**EXPLANATION OF SIGNIFICANT DIFFERENCES**  
**VELSICOL CHEMICAL CORPORATION SUPERFUND SITE**

**OPERABLE UNIT 1**

**SAINT LOUIS, MICHIGAN**

**JULY 2024**

**FIGURE 3**  
 Upgradient Slurry Wall Repair Area  
 Velsicol Chemical Corporation Superfund Site  
 St. Louis, Michigan

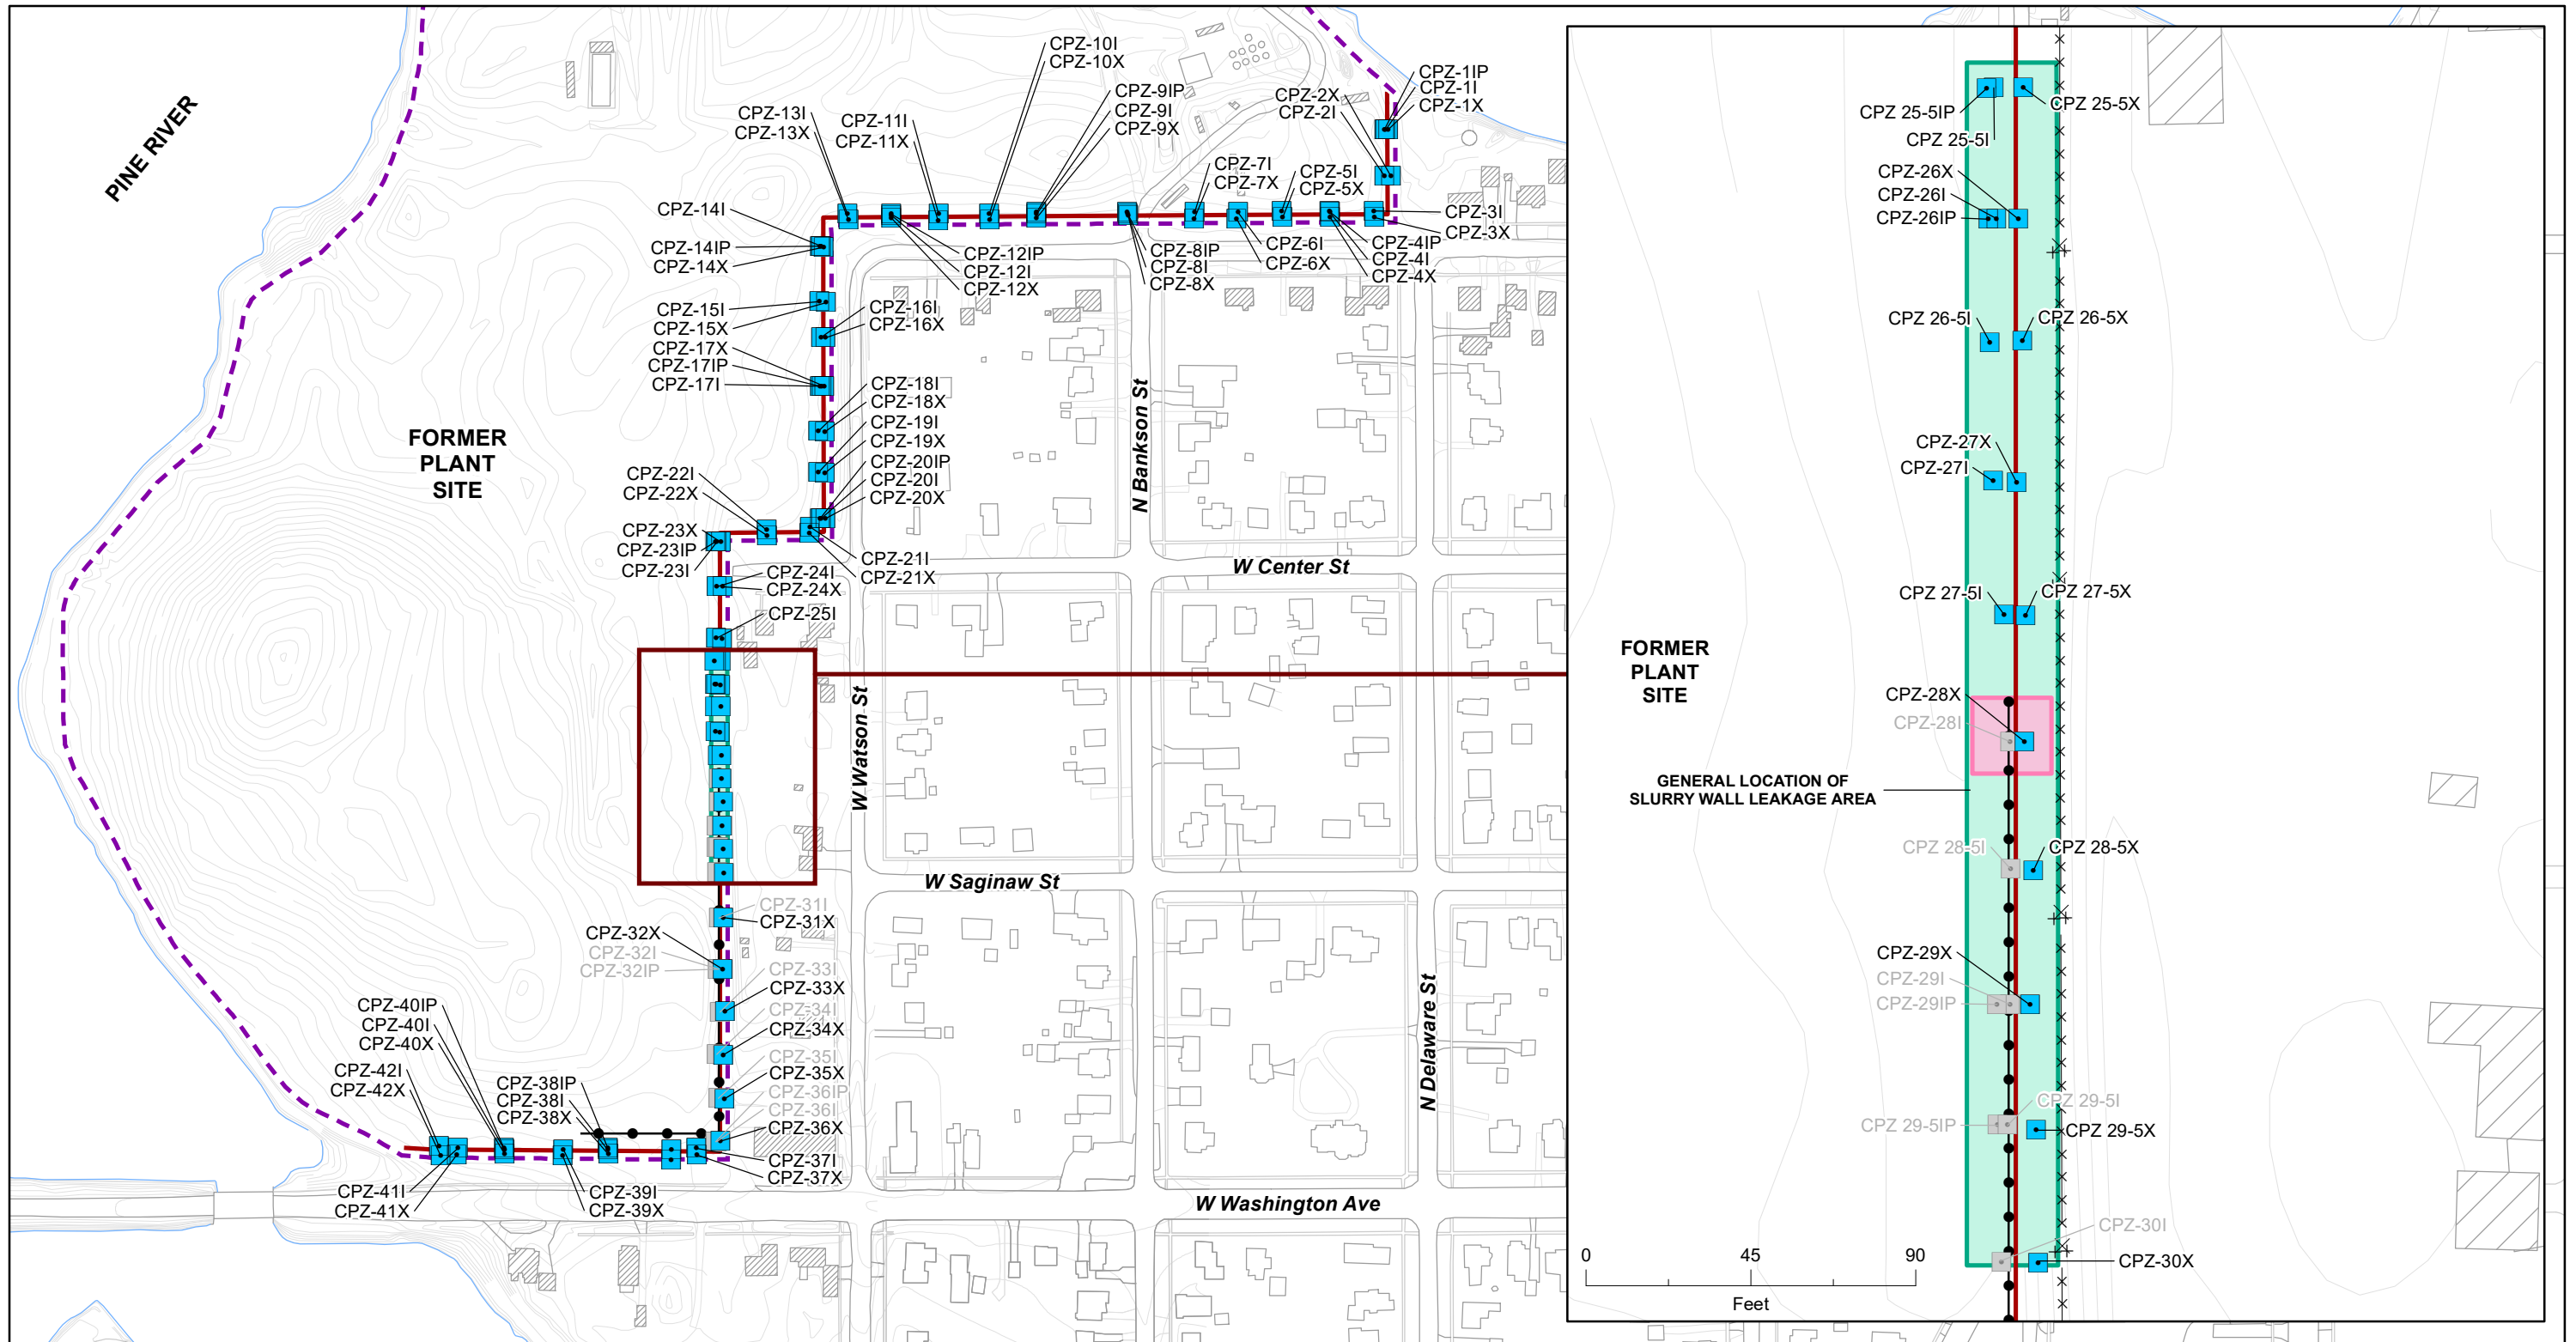
Surrounding the 20-foot breach is an area approximately 350-feet wide between CPZ-30 and CPZ-25 (Figure 3) reflecting substandard hydraulic performance. The substandard performance is defined in this area because inward hydraulic gradients (Appendix C) are observed in piezometer clusters CPZ-27-5 (immediately north of breach area) and CPZ-29 (immediately south of breach area). These inward gradients are likely caused by shallow groundwater inside the FPS discharging through the 20-foot breach, resulting in a depression of groundwater elevations near these locations and diminished localized mounding on the interior side of the slurry wall. The exterior piezometers are unaffected by this process and continue to be a hydraulic barrier. Figure 3 shows the 20-foot breach area and the 350-foot area that will be repaired.

*Soil Boring Logs* – Soil borings completed during the investigation show a 3.25-foot-thick sand lens between the bottom of the slurry wall and the top of the till in this 20-foot area between soil borings CSW-003 and CSW-005 and in the vicinity of piezometer cluster CPZ-28. The sand lens observation indicates that the slurry wall is not keyed into the till at this location (Appendix C).

Since a majority of the upgradient slurry wall is performing adequately, the 20-foot breach and surrounding 350-foot substandard performance area may be repaired in lieu of installing a steel sheet pile wall along the entire 3,100 linear foot upgradient alignment of the slurry wall. Various technologies are available for repair of the upgradient vertical barrier wall. With respect to repairing the current slurry wall versus installation of a new steel sheet pile vertical barrier wall, the upgradient slurry wall repair would be easier and quicker to implement, more effective long-term, and cost approximately one-twentieth what a new sheet pile wall would cost (see Table 5).

An engineering evaluation (CH2M 2024) was conducted and assessed six repair methods. Implementability, effectiveness, design life, and cost were evaluated for each method. Based on that evaluation, the technology to repair the upgradient slurry wall is soil mixing. An upgradient
